Washington Park Building

Certificate of Approval Revision

June 1, 2021

Certificate of Approval Revision - Summary of Modifications:

Block Front Diagram

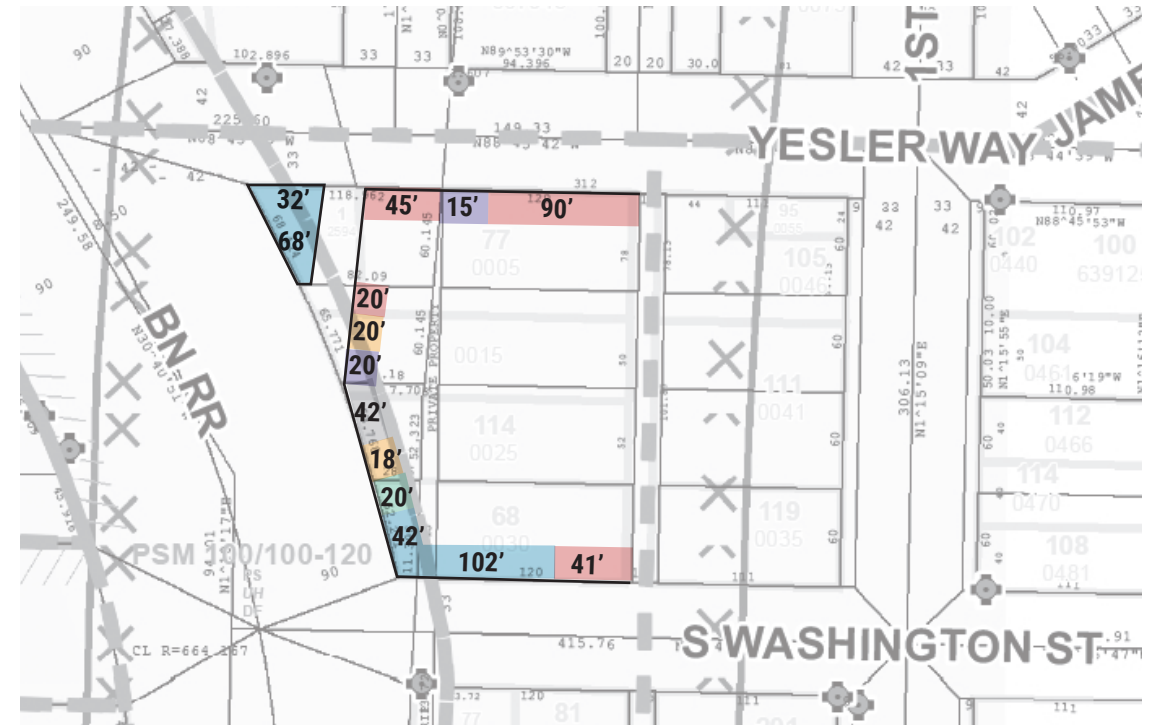
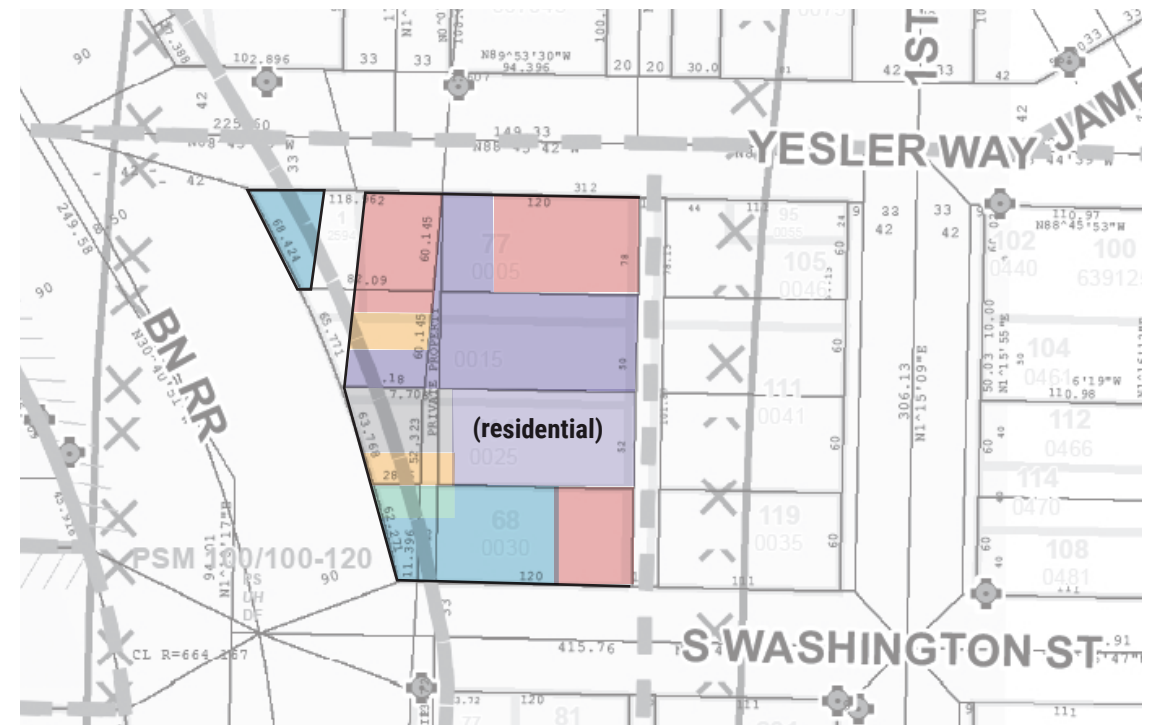
6. Revision of 4,049 sf of street level use from Restaurant to Office. Revision of 1,469 sf of street level use from TBD to Restaurant.

Proposed office use is 264 linear feet, or 46% of street level frontage

Full Block Front:	approx 575LF
Creative Office:	264 LF 46% of street level frontage
Parking Access:	38 LF 7%
Retail/Restaurant:	196 LF 34%
Hotel:	35 LF 6%
Vacant	42 LF 7%

Full Block Area:	approx 36,000 sf
Office Existing:	1,200 sf
Office Proposed:	4,049 sf
Office Lobby (proposed)	1,135 sf
Total Office Use:	18% of block front area

PROPOSED RECONSTRUCTED OF SOUTH BRICK PARAPET AND CORNICE

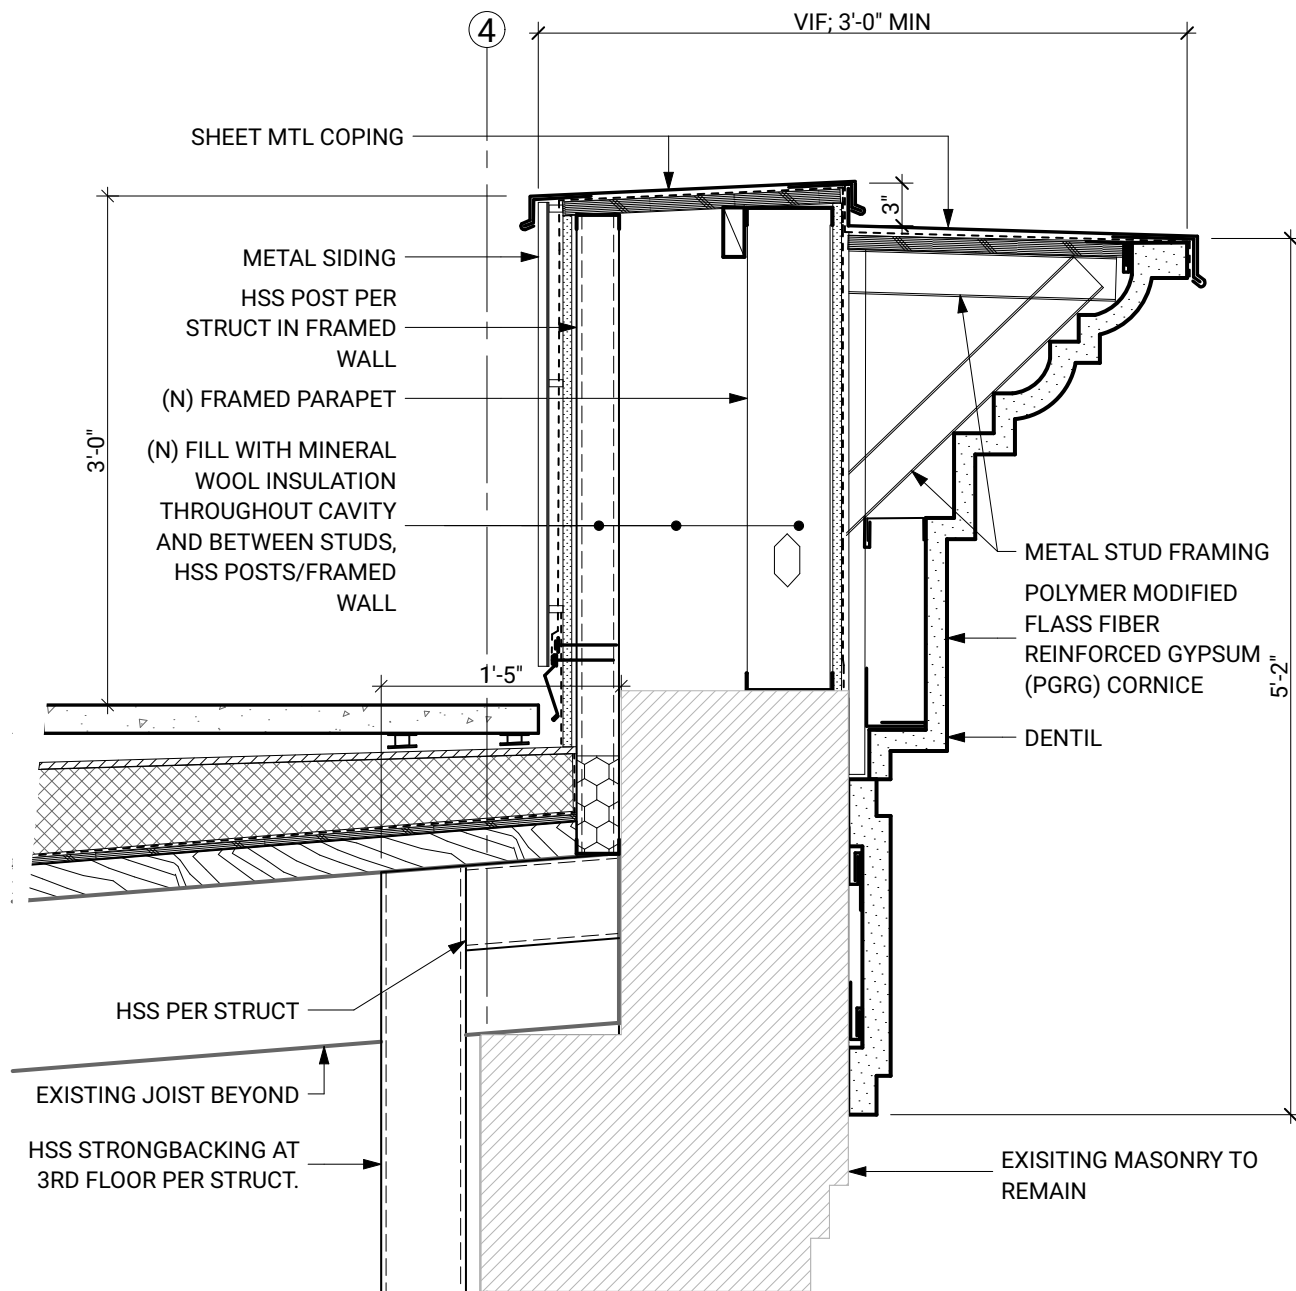
1. The original parapet and cornice, which were removed following the 1949 earthquake, will be reconstructed in brick and cast polymer modified glassfiber reinforced gypsum (PGRG) to match the original design as understood from historic photographs of the building. PGRG cornice to be painted.

PGRG RECONSTRUCTED CORNICE,
APPROXIMATE 5'-0" HEIGHT PER
EXISTING PHOTOS

CONTINUOUS LOWER BAND
PER HISTORIC PHOTOS

EXISTING REVEAL AT LOCATION
OF HISTORIC CORNICE.
EXTEND ACROSS
RE-BUILT PARAPET

2 PROPOSED FIRST FLOOR FIXED WOOD STOREFRONT
NOT TO SCALE

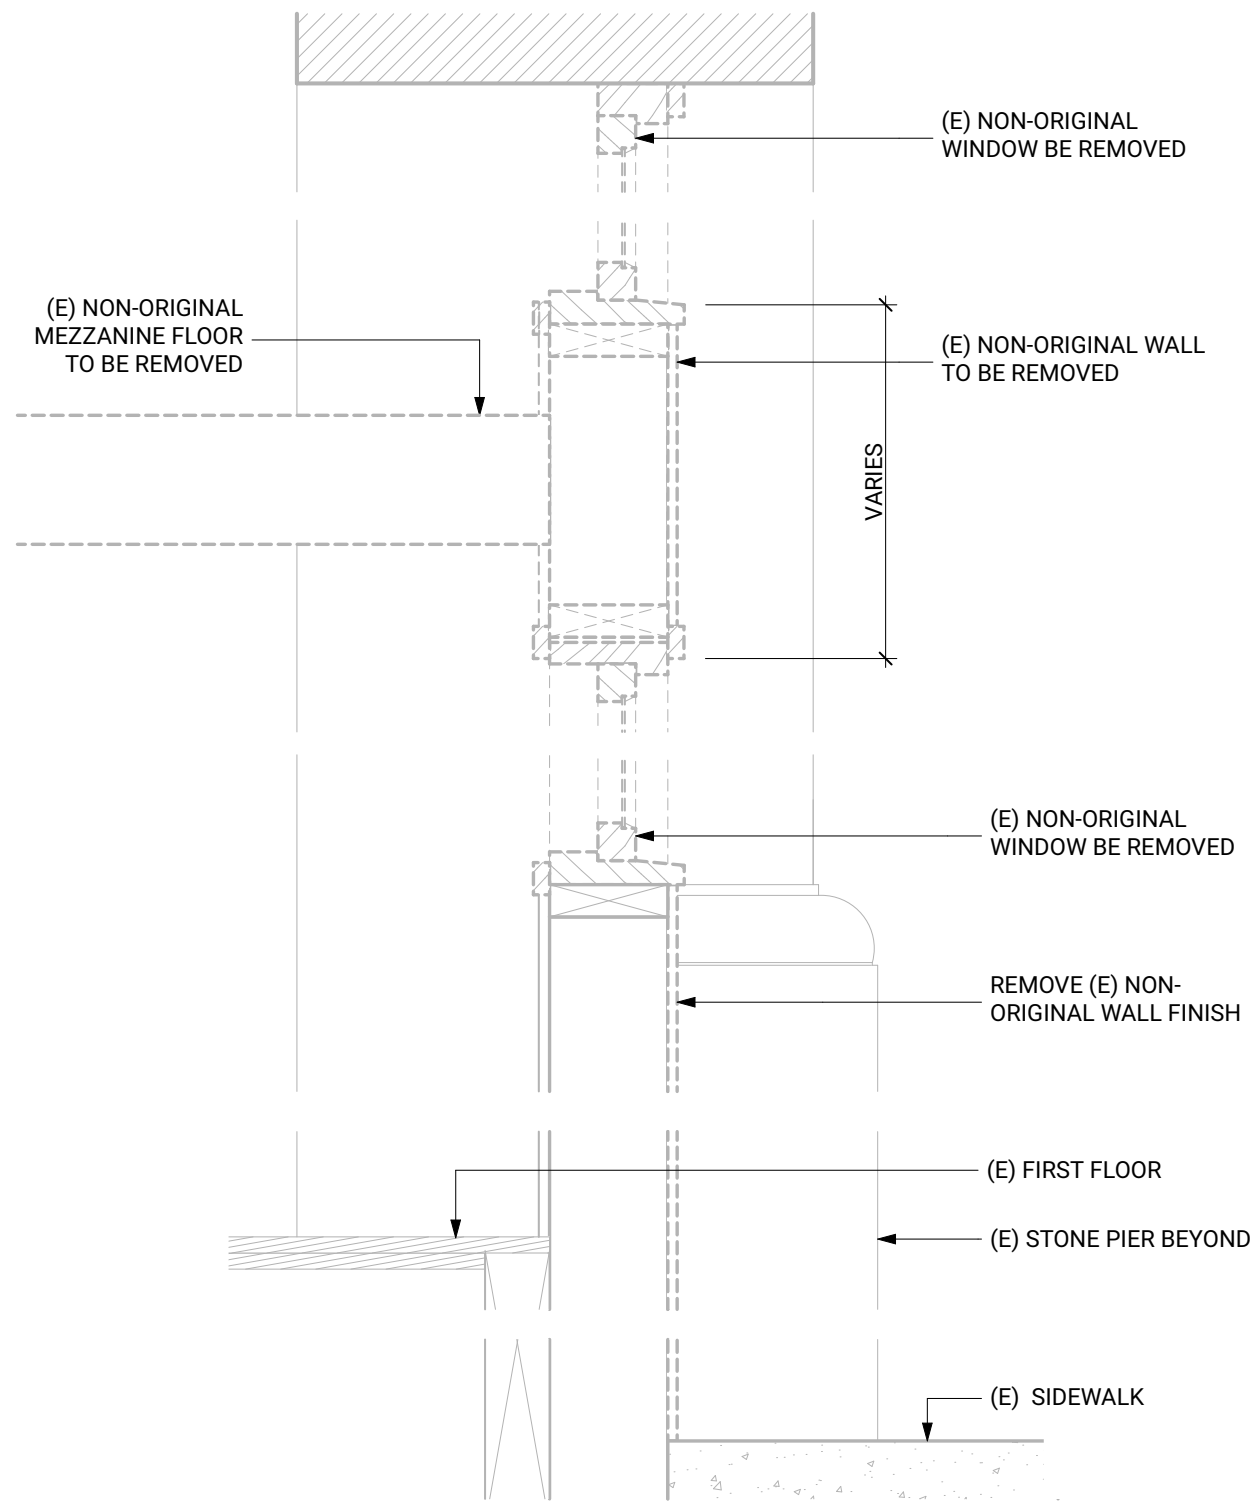
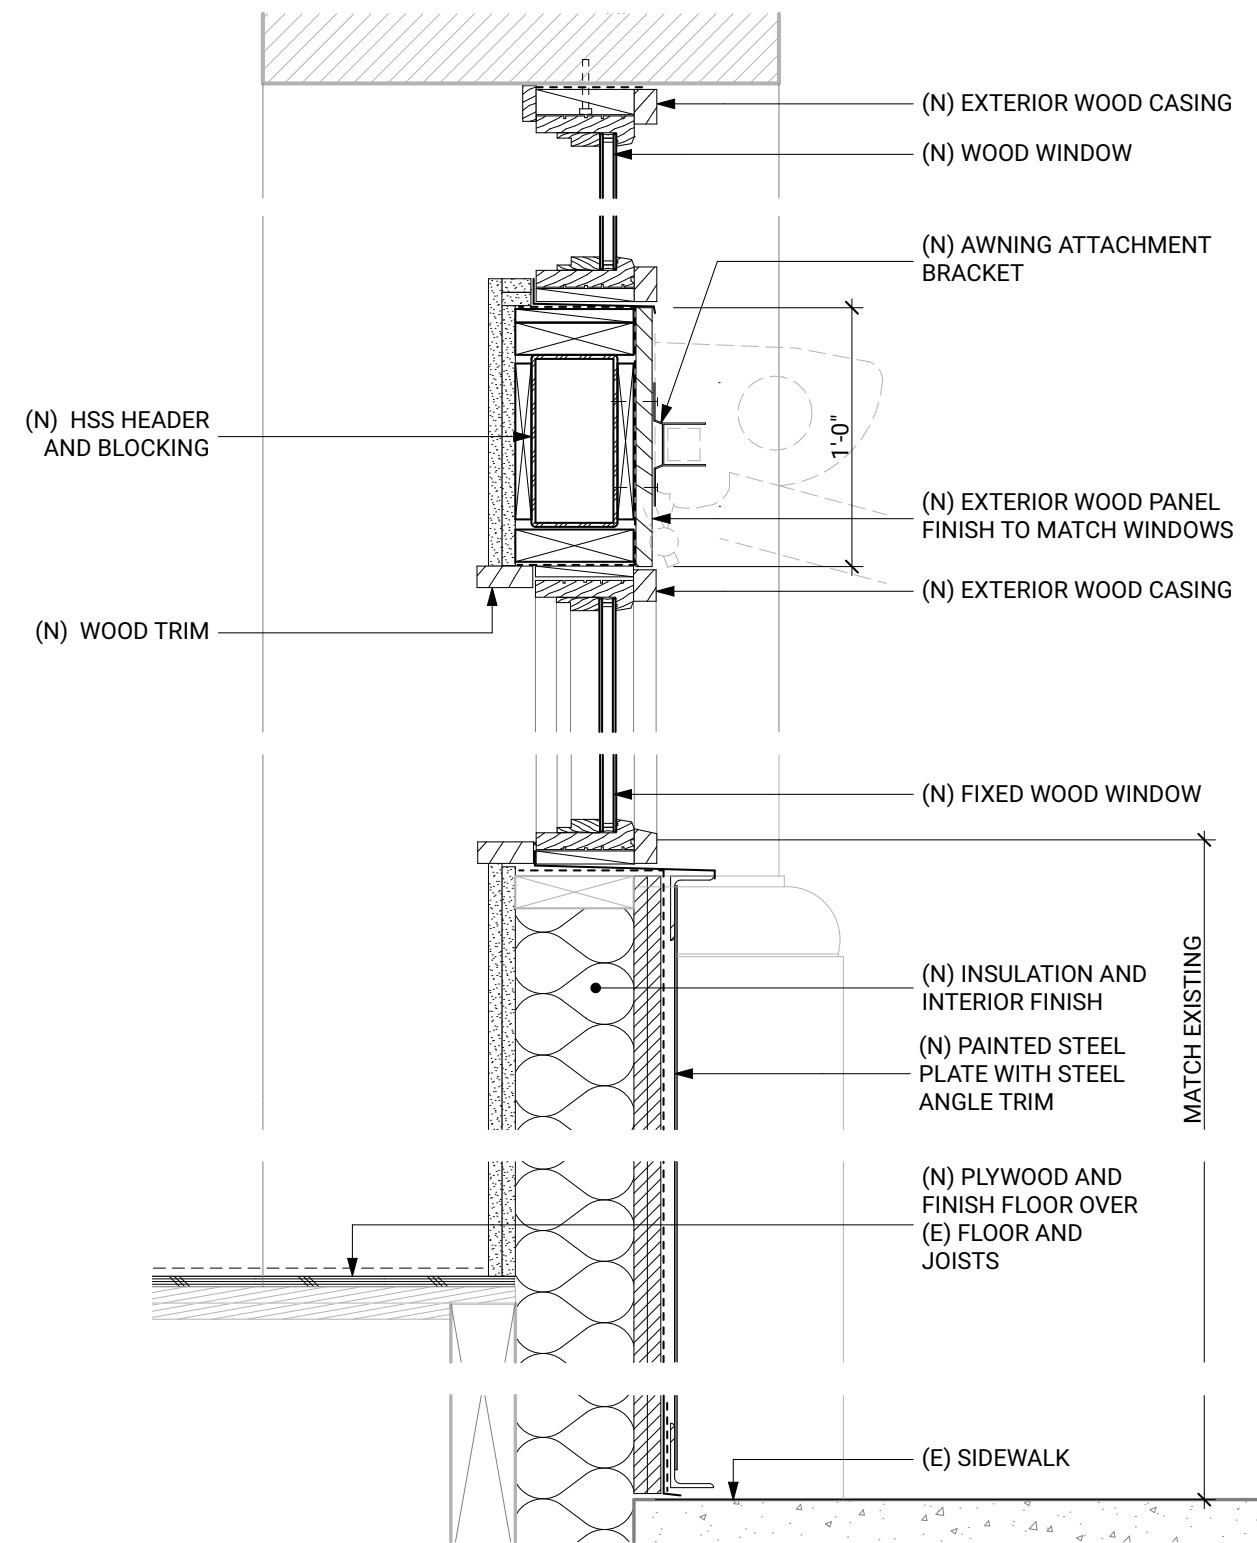
4. All new windows at the street level are to be painted wood storefront. Previous approval proposed windows with sliding operability.
5. Eliminate one previously-approved new entry at the south elevation (to S Washington Street).

FIRST FLOOR NON-ORIGINAL WINDOW REPLACEMENT WITH FIXED ALL-WOOD WINDOWS
PREVIOUSLY APPROVED FOR EAST PORTION OF SOUTH ELEVATION, NOW PROPOSED ALL STOREFRONT LOCATIONS FIRST FLOOR
